PIC18F87J50 Family Silicon Errata and Data Sheet Clarification

The PIC18F87J50 family devices that you have received conform functionally to the current Device Data Sheet (DS39775C), except for the anomalies described in this document.

Data Sheet Clarifications

FIGURE 19-10: I²C™ SLAVE MODE TIMING (TRANSMISSION, 7-BIT ADDRESS)

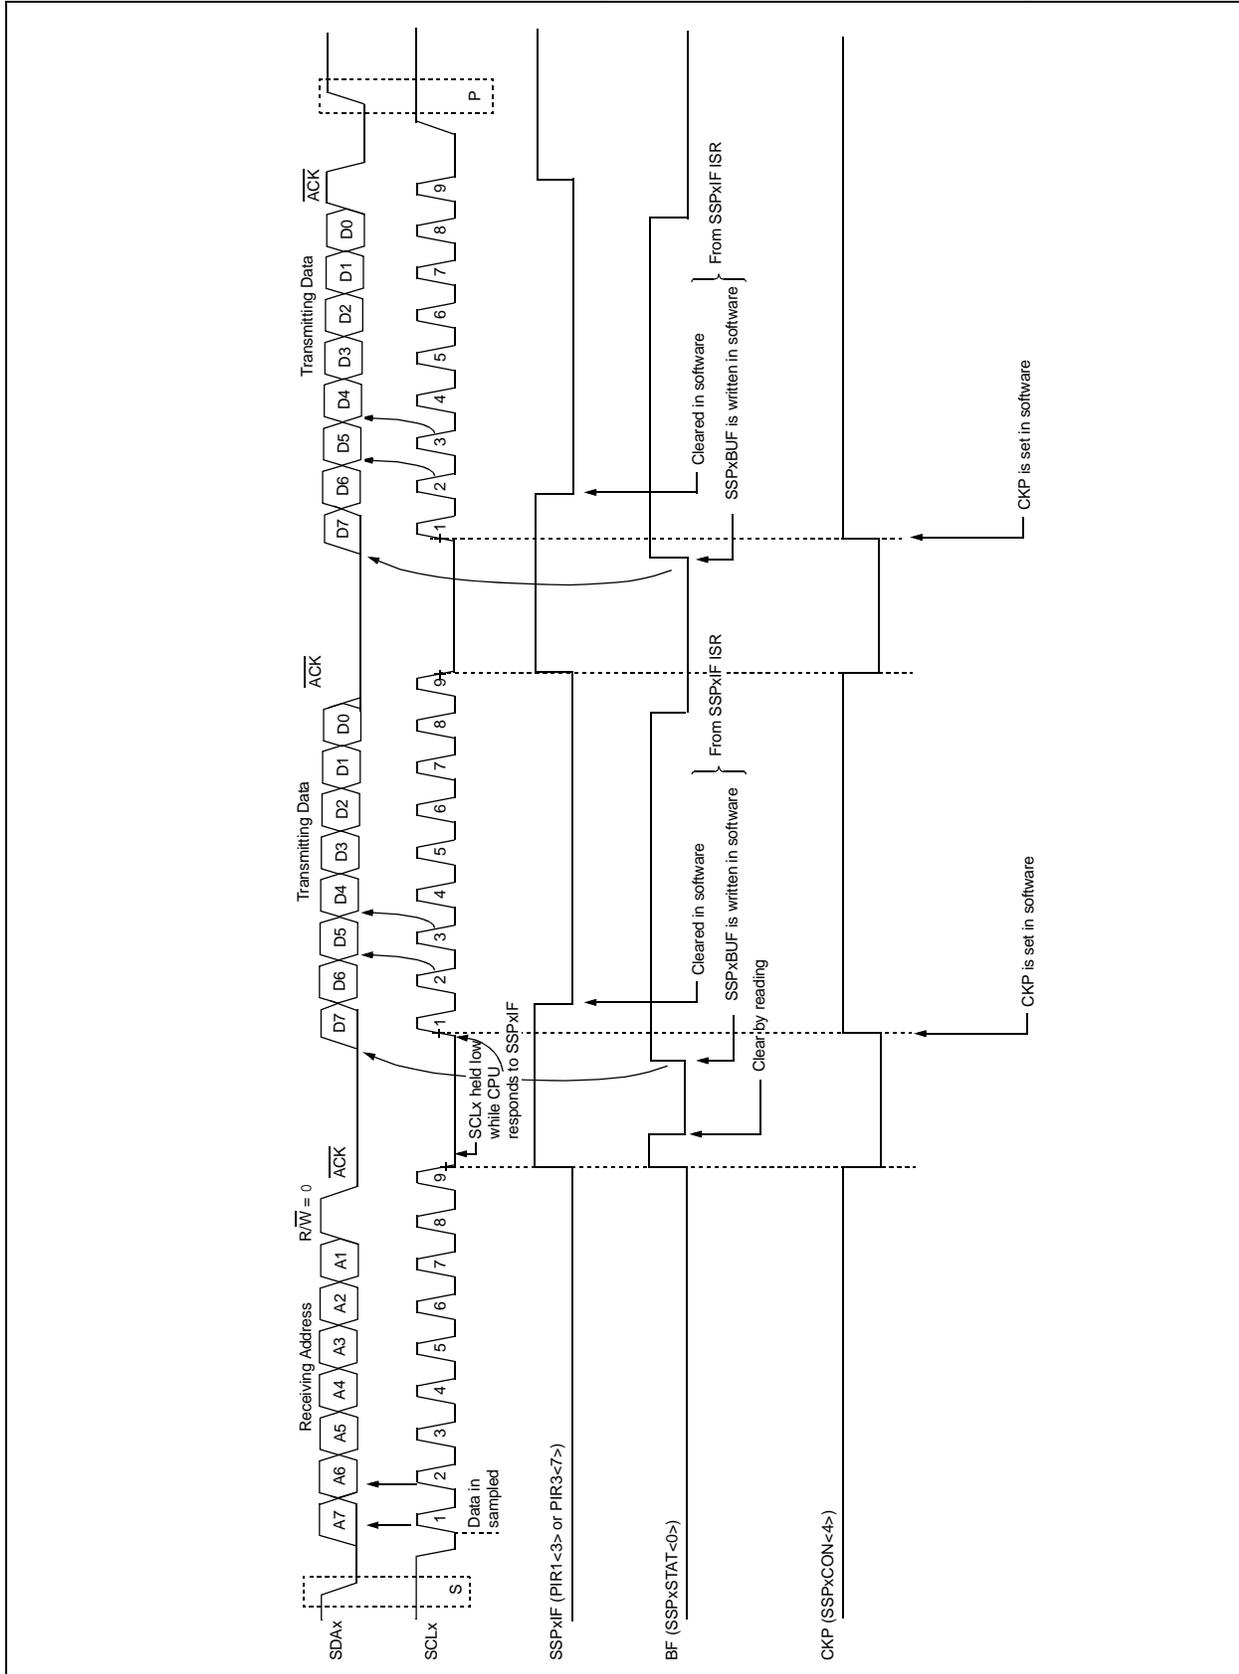
6. Module: Figure 19-10: I²C™ Slave Mode Timing (Transmission, 7-Bit Address)

On page 252, the figure is replaced with the new timing diagram provided in [Figure 19-10](#).
